FRIENDS of Banks Peninsula Inc.

Akaroa Treated Wastewater Options Consultation (2020)

Second draft FULL SUBMISSION

Figure 4 Land projected to be below annual flood level in 2050 in red

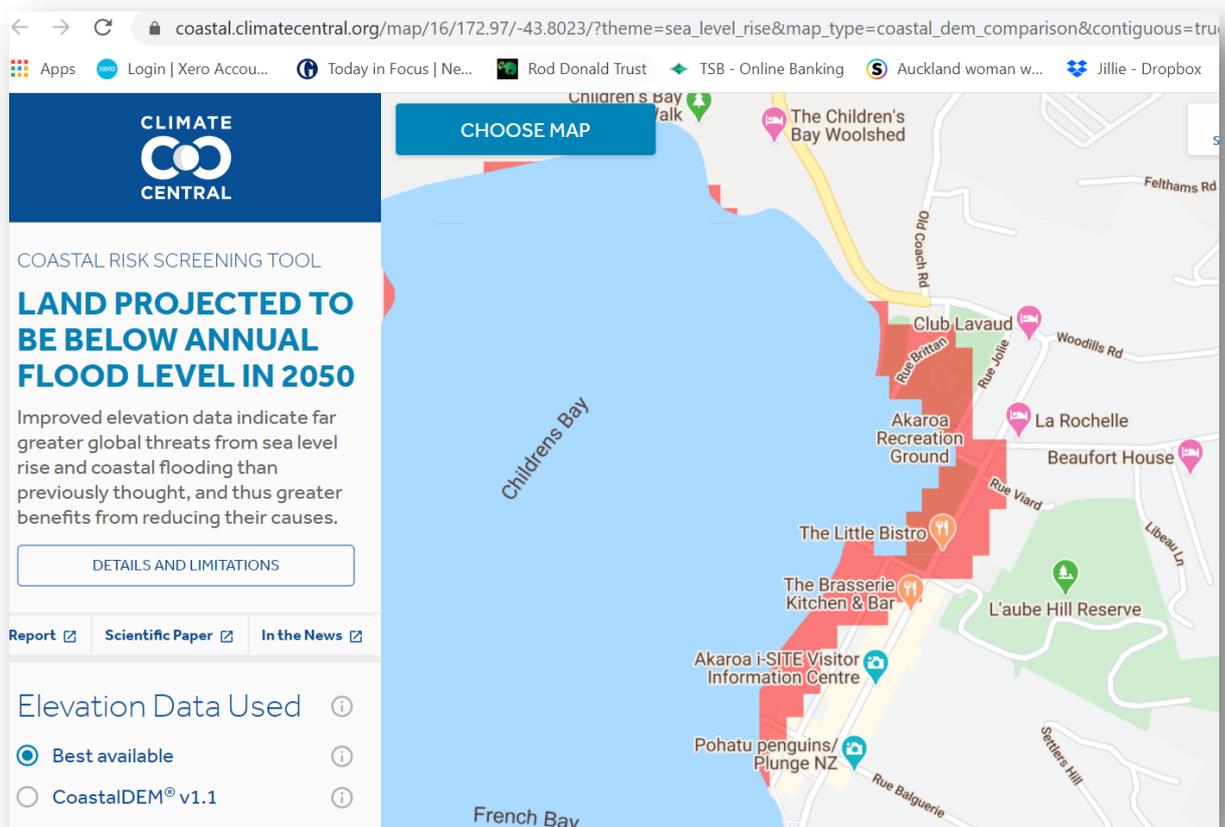
The Terminal Pump Station is located on reclaimed land on top of the former Akaroa refuse disposal site and is only slightly above sea level. The area is projected to be below the annual flood level in 2050.¹²

Figure 5 Large footprint of Inner Bays infrastructure in addition to Treatment Plant infrastructure.

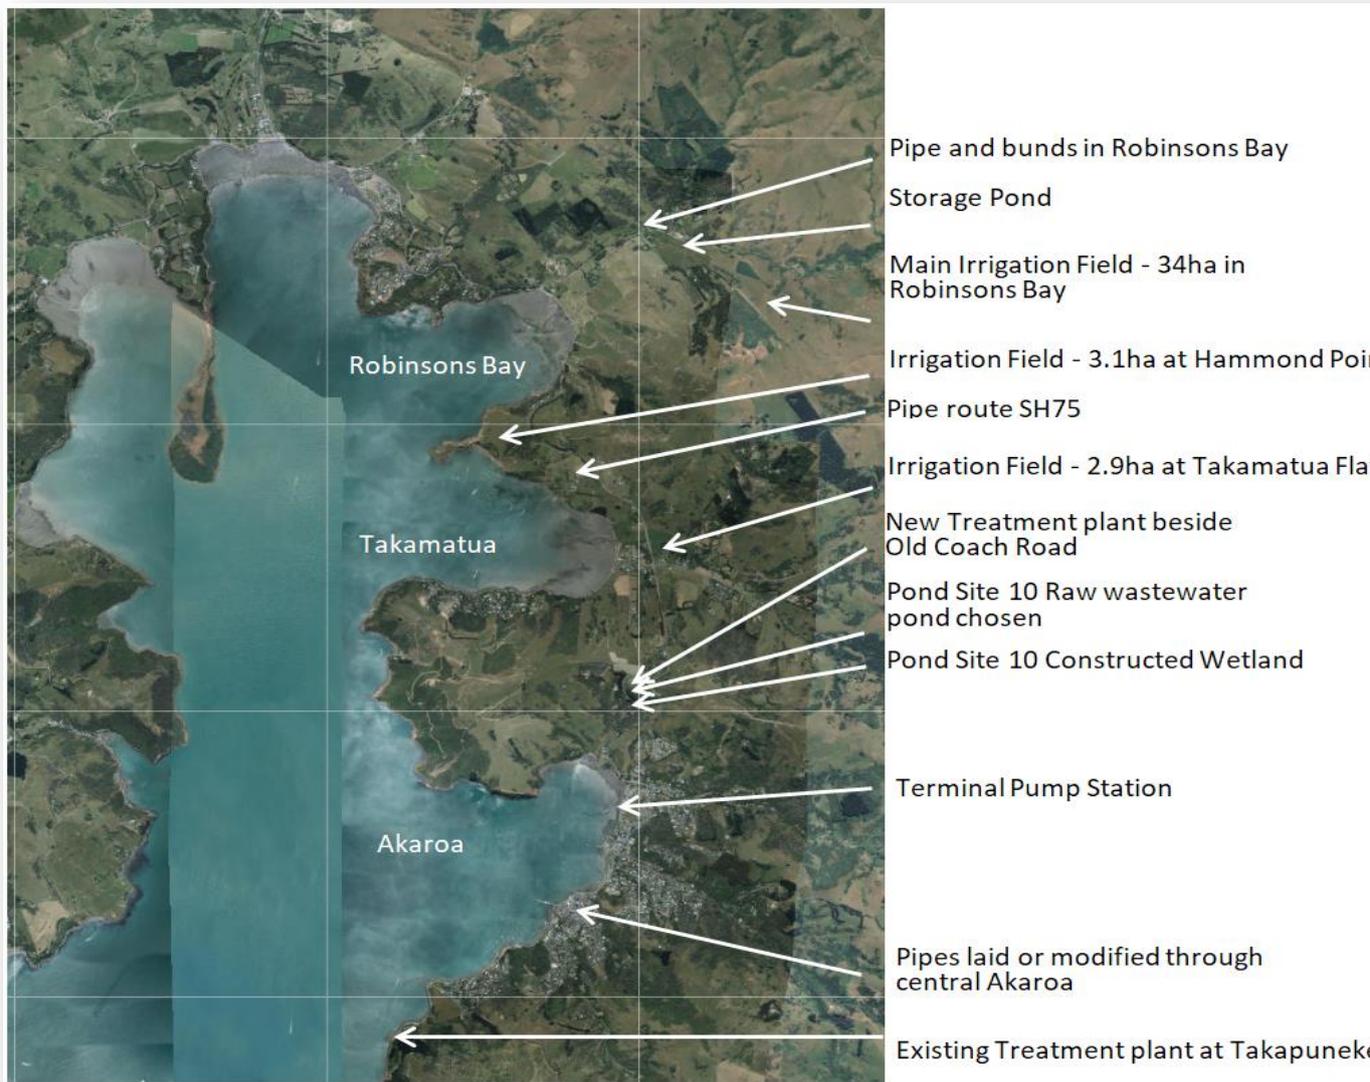
Figure 5 below shows where the Inner Bays option infrastructure would be placed in relation to the new Treatment plant.

This shows the large combined footprint of the new Treatment system with the Inner Bays option. It should be noted that the Duvauchelle scheme will add further wastewater infrastructure into the Inner Bays area on the Duvauchelle golf course and showgrounds should this also become a land based scheme.

Figure 9 Storage Pond Thacker Site

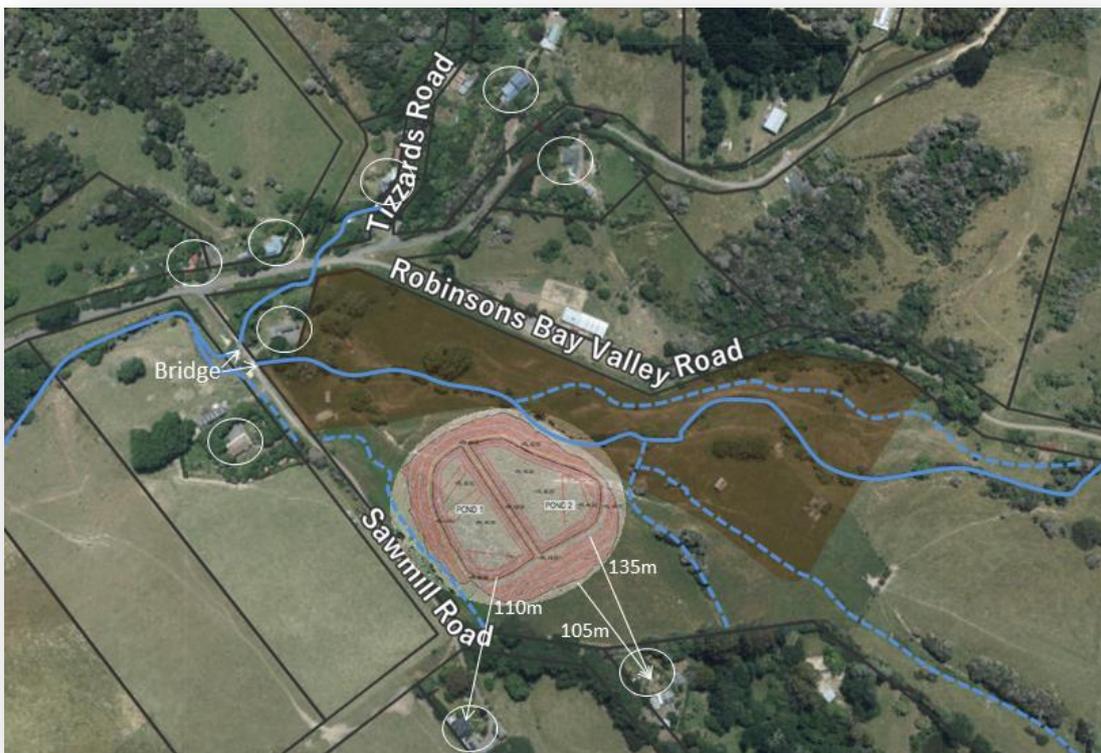
Fitting the 19,000m³ storage pond onto the Thacker Site (11 Sawmill Road) is problematic. See Figure 9 below.

- A double pond with a central bund is designed to reduce the dam break risk to lower properties. A bund has also had to be included along Sawmill Road to lessen the risk of flooding the house opposite should a dam break occur.
- The site has the sawmill archeological site area (shaded brown) immediately below it. The house between the Tizzards and Robinsons Valley streams is the historic Pavitt cottage

- Where the main stream exits the site it passes under a small bridge on Sawmill Road. Should this block during heavy rain (and blockages like this have been the most frequent causes of flooding)³⁴ water could quickly back up below the dam face. The images below show the bridge in normal and in flood conditions, and the type of debris that comes down in a storm. These are provided to show how this constriction below the pond could block in a heavy storm and cause water to build up below the dam face.

Figure 15 Lower part of Robinsons Bay site accurately indicating location of storage pond

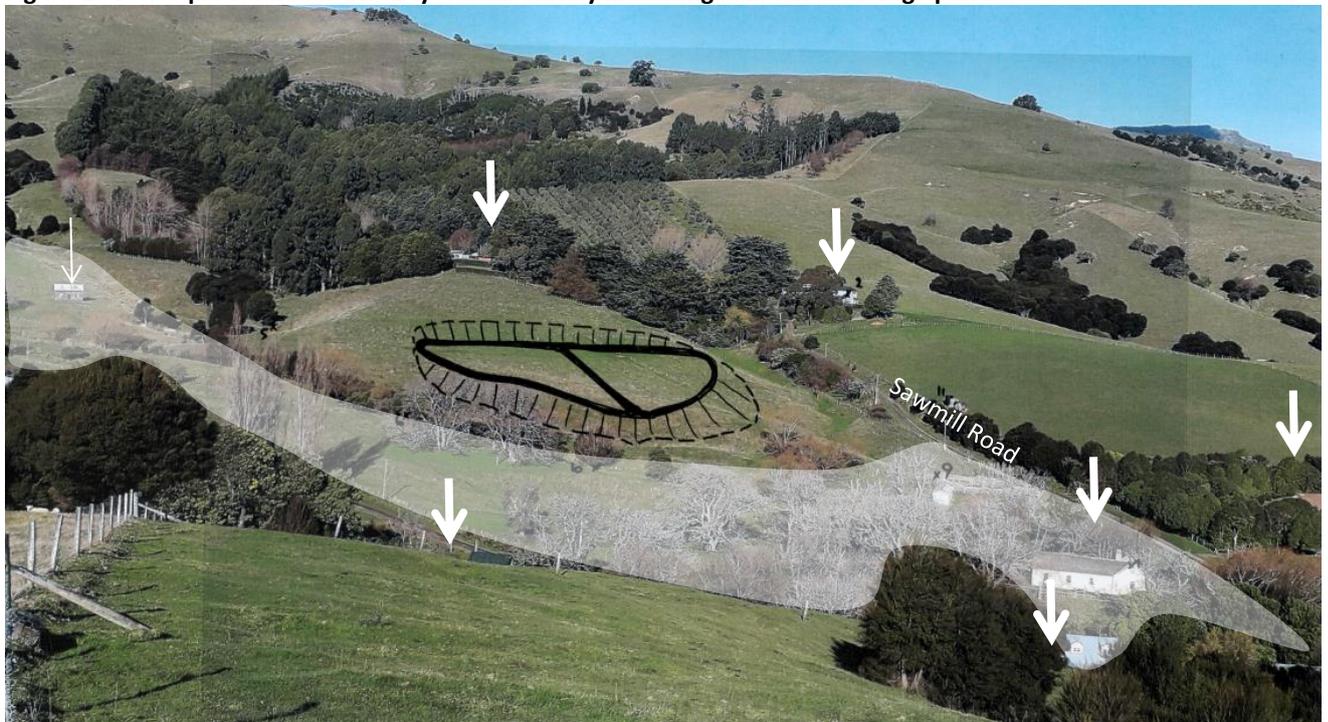
The biggest social impact is on Robinsons Bay because the storage pond is located in the upper valley area adjacent to Sawmill Road and a number of houses as shown in the image below. These are not flagged in the consultation document views.

The white arrows indicate the location of the six houses closest to the site. The white shading indicates the heritage area which housed the mill, millpond, tramway and ancillary buildings. Frederick Wynn Williams (a later mill owner) lived in the cottage now abandoned indicated by the leftmost smaller arrow.

- These properties will be severely impacted during the construction period, when the pond (occupying a construction area the size of four football fields) is excavated and the bund and channel along Sawmill Road are constructed. Noise, mud, dust and truck movements will impact on the nearby residents and those down the valley, and this is expected to take up to a year.⁴²
- In the event that there are issues such as midges, odour, noise, pest birds, inadequately treated water coming through from the Treatment plant, or health impacts, then these are much more likely to cause adverse effects than if the storage pond was placed further away from homes.
- There will be a visual impact from properties that view this site, and from Sawmill Road, Robinsons Valley Road, and further afield from the Okains Bay Road, particularly as the pond

Figure 19 Changes in cost over time

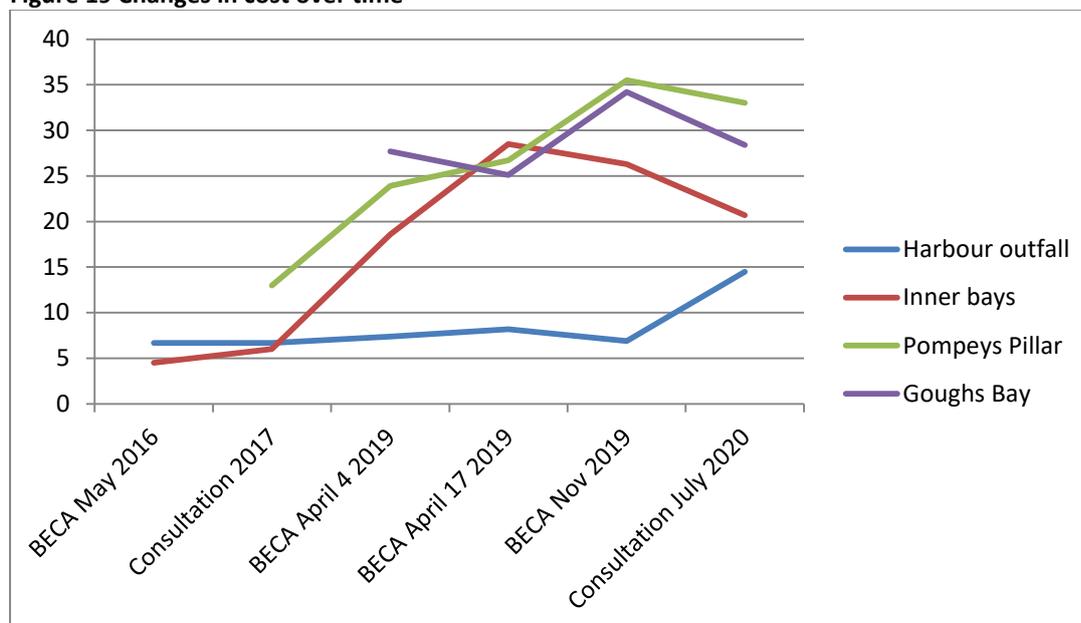
During the past four years of investigation, the costs of the various disposal options have not only risen dramatically, they have also varied significantly relative to each other. The chart below shows the varying cost of each option, presented at different times to the Working Party.
